# Groundwater Transfer Review Summary Form

Transfer/PA # T- 13839

Application: T-13839 Re-Review

Applicant Name: John & Janna Vanden Brink

# Water Levels in Applicant's Wells

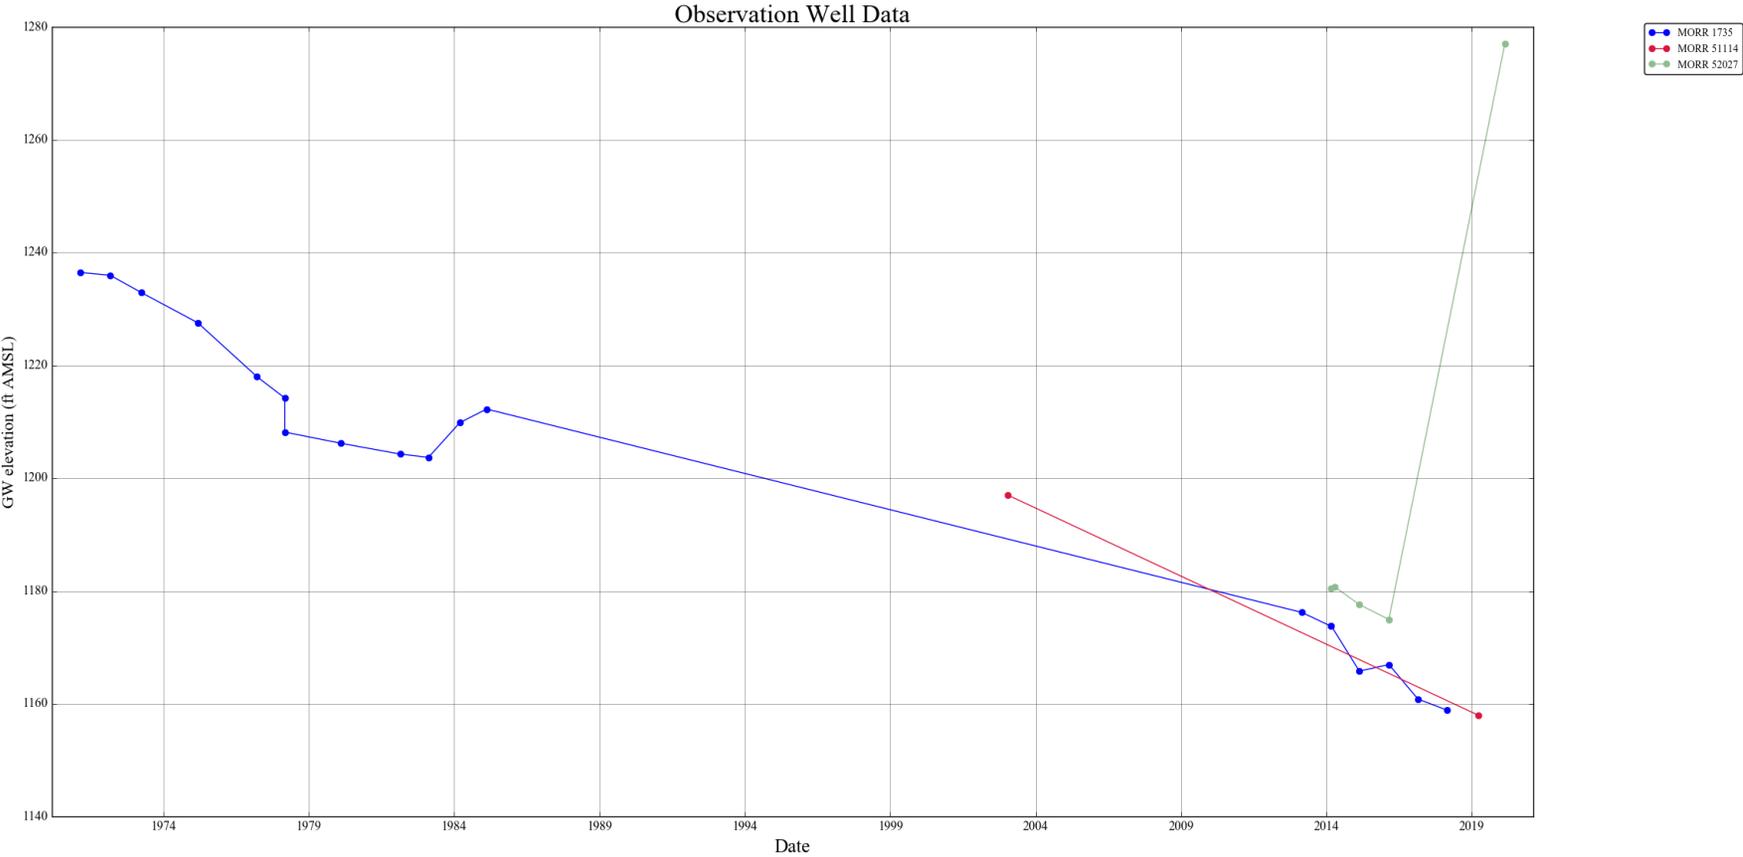
Although multiple WBZs with different hydraulic heads were not noted on the driller’s log, MORR 1735 likely commingles multiples aquifers also. Prior to reconstruction of MORR 52027, swl elevations and trends in all three wells were very similar (see attached hydrograph). Similar water level heads and trends suggests the wells are open to several of the same WBZs and produce (at least partially) from the same aquifer(s). After the upper aquifer was sealed off in MORR 52027, the water level in the well rose about 100 feet. Water levels in MORR 1735 and MORR 51114 did not rise and actually continue to decline. It is likely that MORR 1735 is still open to both primary aquifers, and water is moving through the borehole similarly to MORR 52027 before it was reconstructed. It is also likely MORR 1735 is acting as a conduit connecting lower aquifer water to MORR 51114 (see attached well construction and lithology diagram).
